# ADDENDUM No. 1

ITB No. 4565

## Longshore, Indianola, Ottawa, Argo, Amherst Water Main Replacement Project

DRAWING No. **2018019-3**

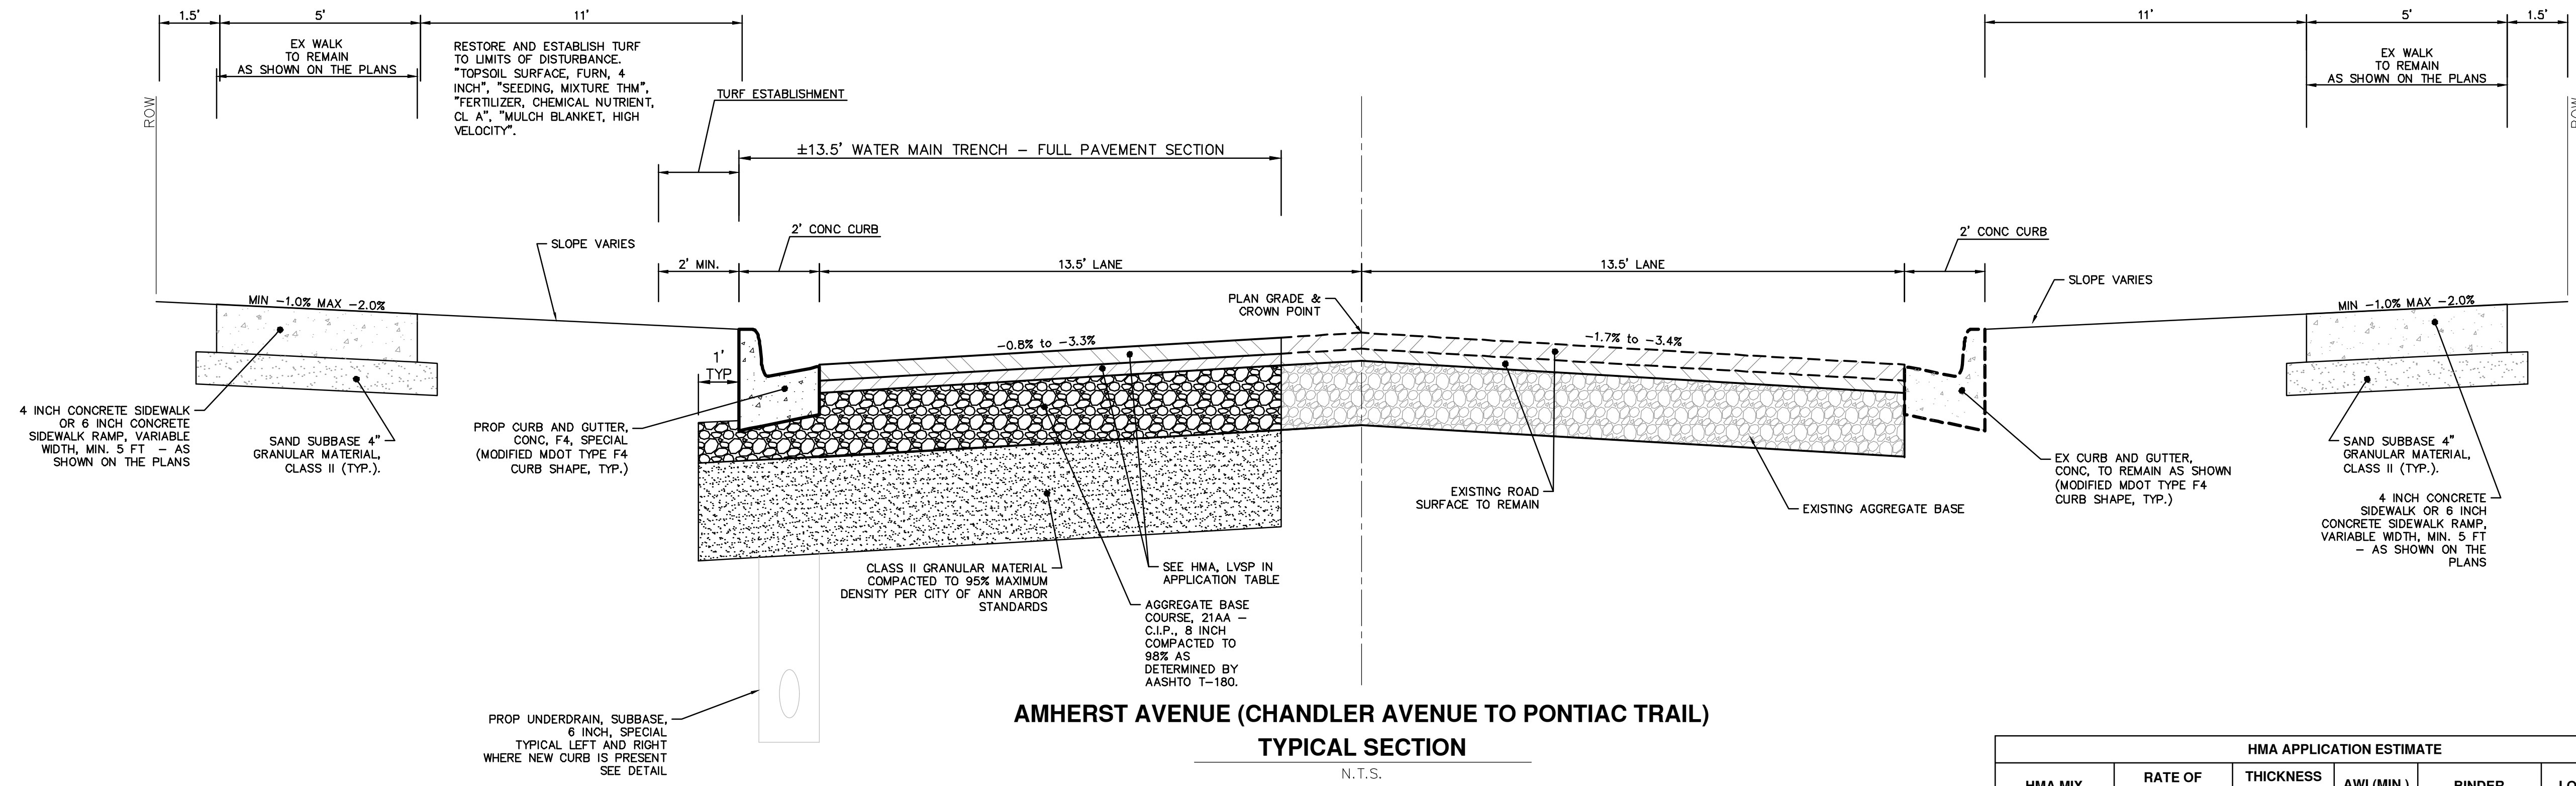
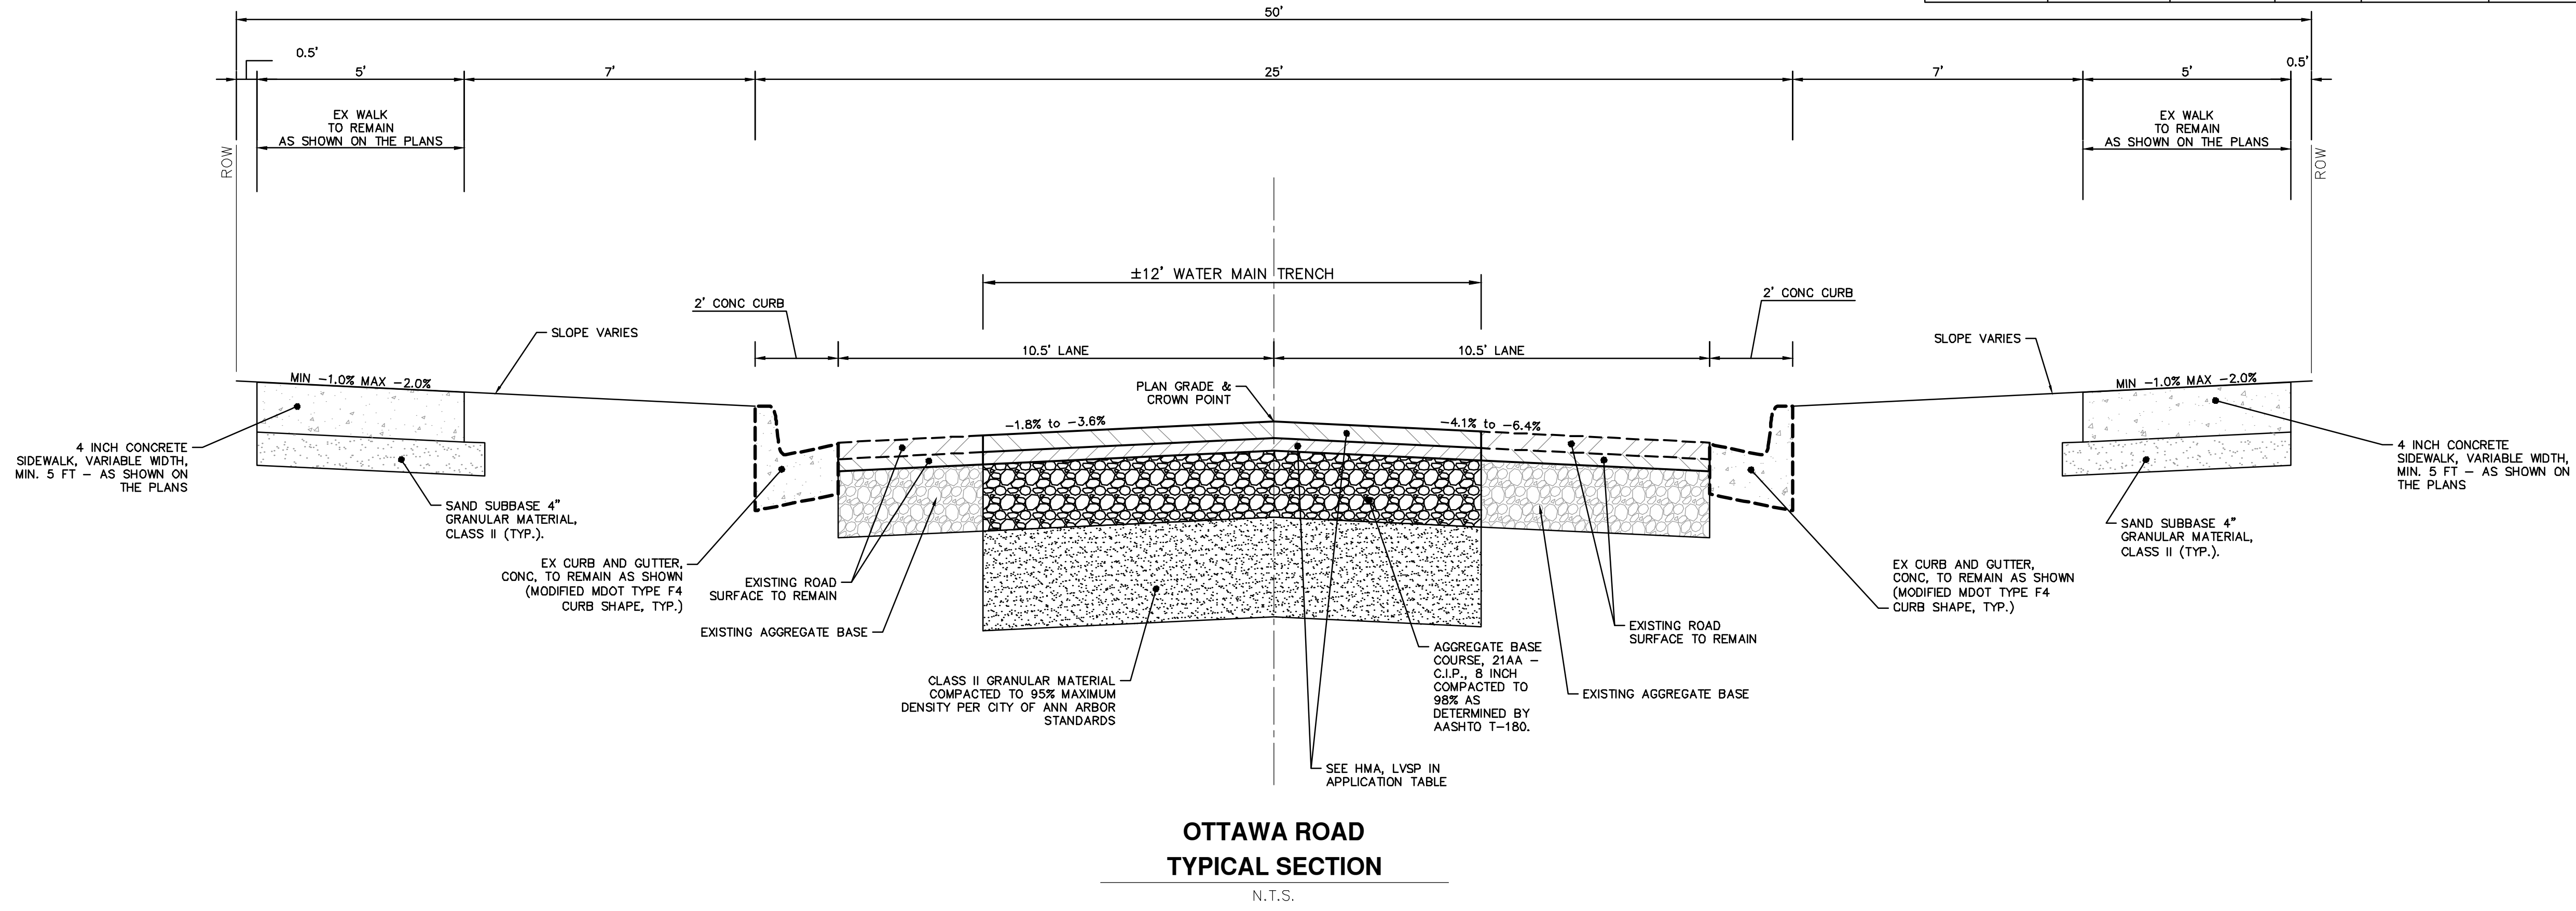
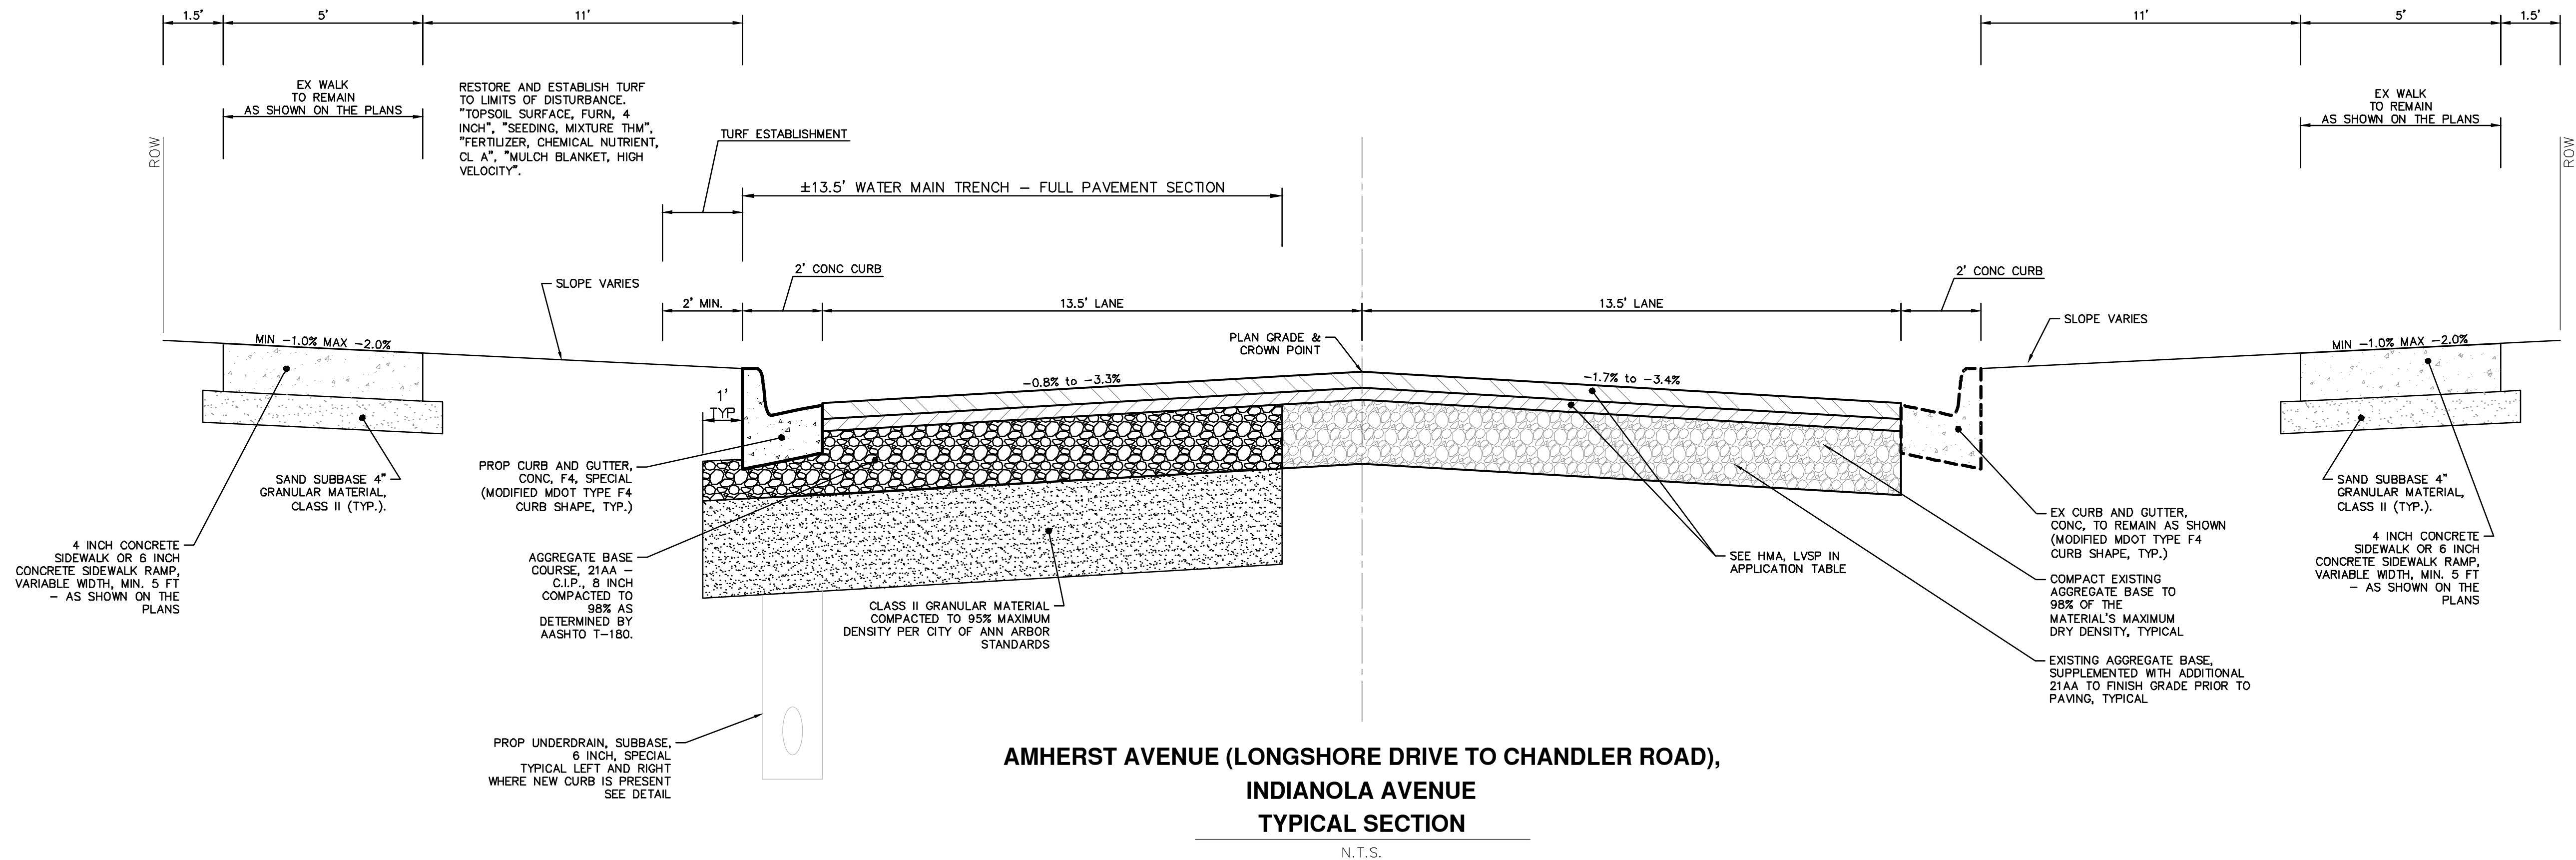
Plan Sheets 4-6 were updated to clarify the pay items and construction methods being used in the Cross-Sections.
